UNITED STATES PATENT AND TRADEMARK OFFICE

APPLICATION NO.	FILING DATE	FIRST NAMED INVENTOR	ATTORNEY DOCKET NO.	CONFIRMATION NO.
10/672,667	09/26/2003	John Jiin Chung Yang	CIP2176A-CTI	9791
7590 09/22/2004 Raymond Y. Chan Suite 128 108 N. Ynez Ave. Monterey Park, CA 91754			EXAMINER PRICE, CARL D	
			ART UNIT 3749	PAPER NUMBER

Office Action Summary	Application No. 10/672,667	Applicant(s) YANG, JOHN JIIN CHUNG 	
	Examiner CARL D. PRICE	Art Unit 3749

(FIGURE 6)

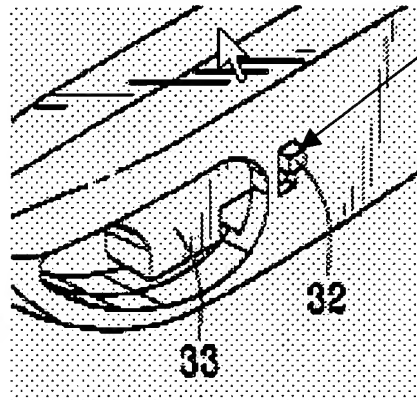
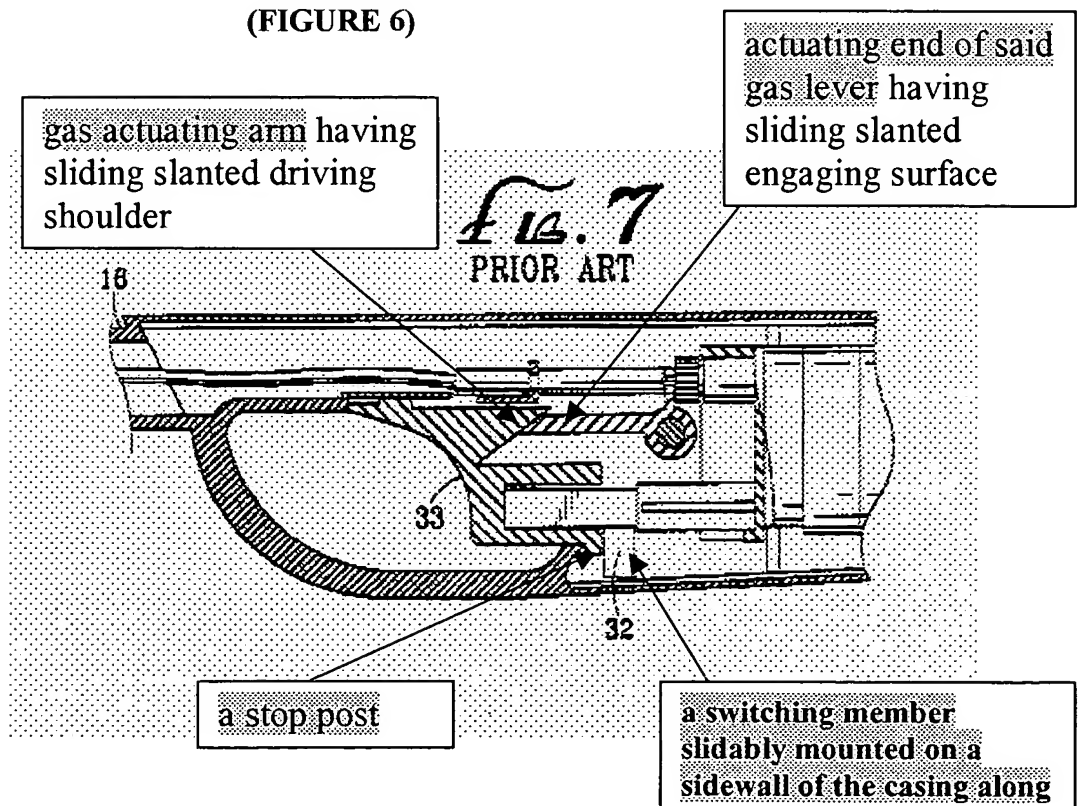
Claims 25-33 are rejected under 35 U.S.C. 103(a) as being unpatentable over US006468070 (JON)(Figures 6 and 7) in view of US006468070 (JON)(FIGURES 5 AND 6)(Figures 1-5), US005409372 (NOBUO) or US006093017A (SAITO).

US006468070 (JON) (Figures 6 and 7) shows and discloses a casing having:

- a lighter housing, which has an internal cavity and a pusher cavity therein,
- a tubular lighter rod (16) extended from the lighter housing,
- the lighter housing has a safety slot (at 32) provided on a sidewall of the lighter housing to communicate the internal cavity with an exterior of the lighter housing,
- a fuel storage housing (30) disposed in the internal cavity of the lighter housing for storing liquefied gaseous fuel;
- an ignition system which comprises
 - o a gas emitting nozzle (31) communicated with the fuel storage housing for releasing gaseous fuel;
 - o a gas tube extended from the gas emitting nozzle to a top end portion of the lighter rod to form an ignition tip therein,

- a piezoelectric unit (40) supported in the internal cavity for generating piezoelectricity, wherein the piezoelectric unit comprises a movable pad and a spark generating tip extended to the ignition tip through the lighter rod for generating sparks when the movable pad of the piezoelectric unit is depressed; and

- a pusher button (33) which is supported in the pusher cavity in a slidably movable manner to drive the movable pad of the piezoelectric unit to be depressed;

- a gas releasing unit for control a flow of the liquefied fuel, wherein the gas releasing unit comprises a gas lever (not referenced in Figure 7; see (70,50,90) in Figure 2) having a pivot end engaged with the gas emitting nozzle and an actuating end arranged to be depressed so as to pivotally lift up the gas emitting nozzle for releasing the liquefied fuel, and a gas actuating arm integrally extended from the pusher button towards the actuating end of the gas lever such that when the pusher button is depressed, the gas actuating arm is driven to depress the actuating end of the gas lever for releasing the liquefied fuel so as to ignite the liquefied fuel at the ignition tip; and

- a safety arrangement, which comprises:
 - o a stop post integrally extended from the pusher button at a position parallel to the gas actuating arm;
 - o a locking member, which comprises a switching member slidably mounted on the sidewall of the casing along the safety slot and a stopper which is

integrally extended from the switching member into the lighter housing through the safety slot and is normally blocked up the pusher button sliding towards the piezoelectric unit,

gas actuating arm having sliding slanted driving shoulder

actuating end of said gas lever having sliding slanted engaging surface

a stop post

a switching member slidably mounted on a sidewall of the casing along

- wherein the safety slot is transversely provided on the sidewall of the lighter housing with respect to a sliding movement of the pusher button, wherein the switching member is slid on the sidewall of the lighter housing along the safety slot to drive the stopper between a locked position and an unlocked position, wherein at the locked position, the stop post is aligned with the stopper such that the pusher button is blocked to be pushed towards the piezoelectric unit for ignition, and at the unlocked position, the switch member is slid on the sidewall of the light housing along the safety slot to drive the stopper to move to an offset position that allows the pusher button to be depressed to depress the movable part of the piezoelectric unit and to depress the actuating end of the gas lever simultaneously for igniting the utility lighter,

- and a resilient element supported in the internal cavity of the lighter housing for urging a pushing force to the locking member to normally retain the locking member at the locked position.

US006468070 (JON)(FIGURES 5 AND 6) discloses the invention substantially as set forth in the claims with possible exception to a resilient element supported in the internal cavity of the lighter housing for urging a pushing force to the locking member to normally retain the locking member at the locked position.
